APPLICATION

FOR PERCOLATION TESTING AND SITE EVALUATION

RE: Percolation Test Results – A 520021
TM 34, Parcels 114 and 216, Nichols Drive
Two Parcels of Record as One Buildable Unit

PERCOLATION CERTIFICATION PLAN
PLOT PLAN FOR PERC TEST
Tax Map 32, Parcels 114 & 216
13695 Nichols Drive
BAMISAIYE PROPERTY
Clarksville (8th) Election District
Howard County, Maryland
(PC-520021)

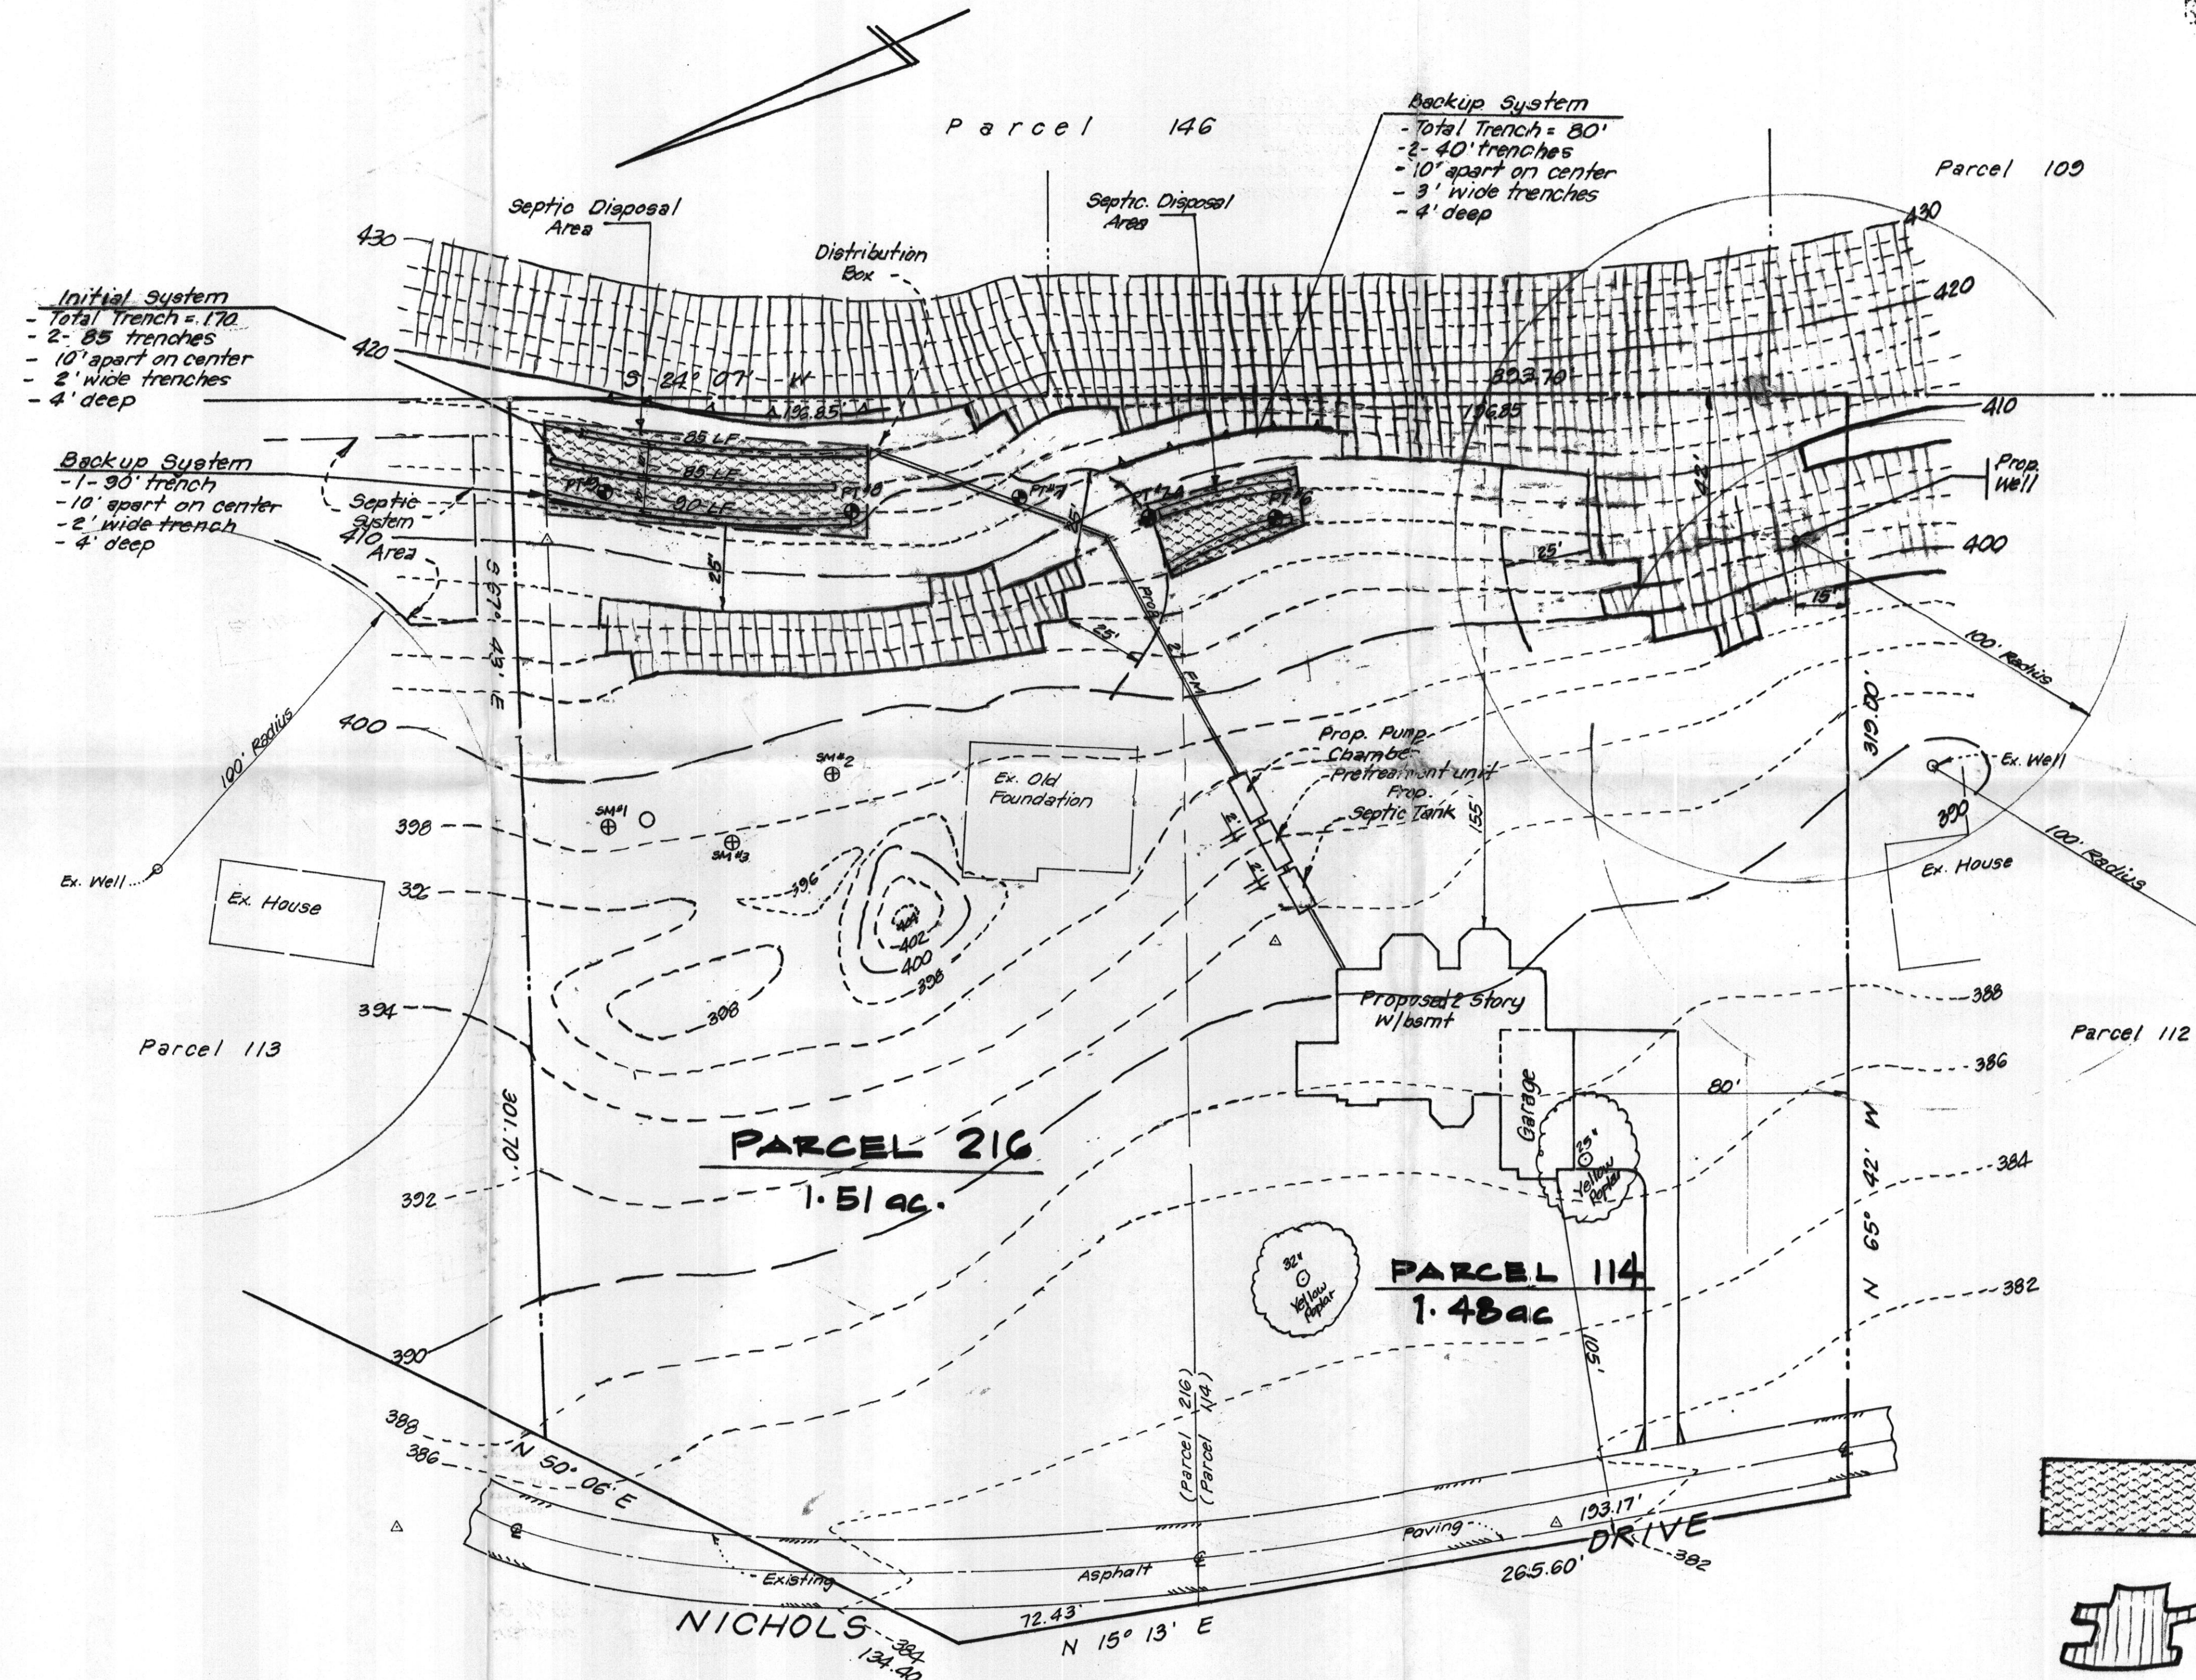
Percolation testing conducted June 9, 2004 on the referenced property indicated limited satisfactory soil conditions for conventional trench designs and unsatisfactory soils for sand mounds. The primary limiting factors for sand mounds are disturbed soils and slow test times produced by dense clay layers; the primary limiting factors for conventional trench designs are slow test times created by deep clay layers and proximity to steep slopes. Copies of the test results are enclosed.

Further review is contingent upon submission by a registered engineer/surveyor of a percolation certification plan showing the following:

- 1) actual locations of all excavated test holes with field-verified topography; the field-run topography currently shown in the vicinity of the proposed sewage reserve area should be verified, as field observations appear to indicate some non-steep slopes where steep (> 25%) slopes are shown; all steep slopes should be marked
- 2) two proposed sewage reserve areas, each showing one system (one based on holes 6 & 7A showing 230' of trench and one based on holes 8 & 9 showing 240' trench)
- 3) proposed house and well site
- 4) statement that all wells and septic systems within 100 feet of property boundaries are shown
- 5) statement indicating that depicted topography reflects field-verified information
- 6) the plan identification number (PC 520021) in the title block

7) committing to offsite easement on P. 216 to serve P. 114 prior to well permit (SR)

While a sewage reserve area cannot be approved less than 25' from downhill steep slopes, a sewage reserve area less than 25' from the steep slopes uphill may be potentially approvable, contingent upon two conditions. These two conditions are 1) commitment to install a berm and curtain drain located at the toe of the steep slopes and at least ten feet uphill of the highest proposed sewage trench; and 2) statement that approval of a variance request to MDE to the 25' separation to steep slopes required by regulation (COMAR 26.04.02.04.J1.) must be issued prior to well permit approval.

In addition, due to the parcels' proximity (< 2500') to the Triadelphia Reservoir, Health Dept. approval is also contingent upon commitment to one of the following: 1) recording a plat combining the parcels as a single unit; or 2) statement that approval of a variance request to MDE to the 2-acre minimum lot size required by regulation (COMAR 26.04.02.04.K) must be issued prior to well permit approval **and** commitment to pre-treatment system installation designed to remove at least 50% of the nitrates from sewage.

- ~~Off-site sewage easement on Parcel 216 to serve Parcel 114 to be recorded in land records prior to well permit.~~
 - Install a berm and curtain drain located at the top of the steep slopes and at least 10 feet uphill of the highest proposed sewage trench.

- Variance request to MDE to the 25' separation to steep slopes uphill required by regulation (COMAR 26.04.02.04.J1) must be issued prior to well permit approval.

- Variance request to MDE to the 2-acre minimum lot size required by regulation (COMAR 26.04.02.04.K) must be issued prior to well permit approval. Pre-treatment system installation designed to remove at least 50% of the nitrates from sewage, must be installed with all septic systems.

- Septic system designed for 4 bedrooms. No additional bedrooms will be permitted without additional septic capacity.
 - WELL APPLICATION TO BE SUBMITTED AFTER ADJOINER CONVEYANCE IS APPROVED THAT COMBINES PARCEL 216 & 114.
